UNITED STATES PATENT AND TRADEMARK OFFICE

Office Action Summary

09/876,396

DETAILED ACTION

Annotated Figure 14

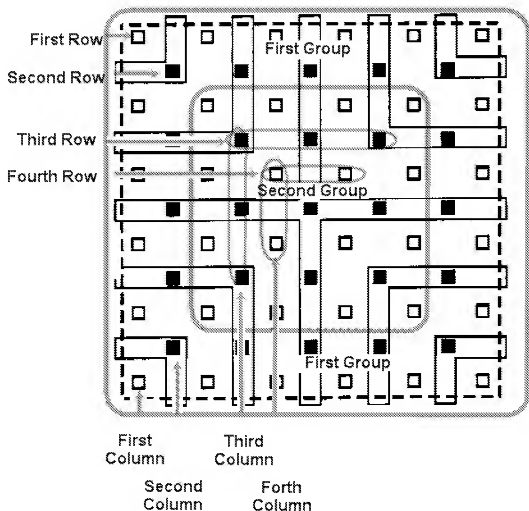
the interconnect pads forming a plurality of I/O cells including signal terminals, a portion of the I/O cells forming a first group (see annotated Fig 14, "+Shape (plus)", for

example- first group considered as the outer area of pads labeled "First Group") of I/O cells and another portion of the I/O cells forming a second group (see annotated Fig 14 "+Shape (plus)", for example- second group considered as inner area of pads labeled as "Second Group") of I/O cells on an inner position of the mounting member with respect to the first group of I/O cells, the first group of I/O cells including a plurality of rows of interconnect pads (see Fig 14, for example) disposed to encircle a center of the mounting member, and the second group of I/O cells including a plurality of rows of interconnect pads (see Fig 14 for example) disposed to encircle a center of the mounting member (also col 11 lines 48—col 12 line 40), the first and second groups of I/O cells being disposed directly under the semiconductor member (see Fig 2), wherein:

the first group of I/O cells arranged in a first row, a first column perpendicular to the first row (see annotated Fig 14, "First Row" and "First Column", for example), a second row disposed on an inner position relative to the first row, and a second column that is perpendicular to the second row and disposed on an inner position relative to the first column (see annotated Fig 14, "Second Row" and "Second Column", for example; arrows indicate that the rows and columns are inner to the first)

the second group of I/O cells arranged in a third row, a third column perpendicular to the third row (see annotated Fig 14, "Third Row" and "Third Column", for example), a fourth row disposed on an inner position relative to the third row, and a fourth column that is perpendicular to the fourth row and disposed on an inner position relative to the third column (see annotated Fig 14, "Fourth Row" and "Fourth Column", for example; arrows indicate that rows and columns are inner to the third);

each of the first and second rows and first and second columns of the first group of I/O cells are arranged parallel to any portion of an outer periphery of the semiconductor member, and

each of the third and fourth rows of the second group of I/O cells are arranged parallel to any portion of the outer periphery of the semiconductor member.
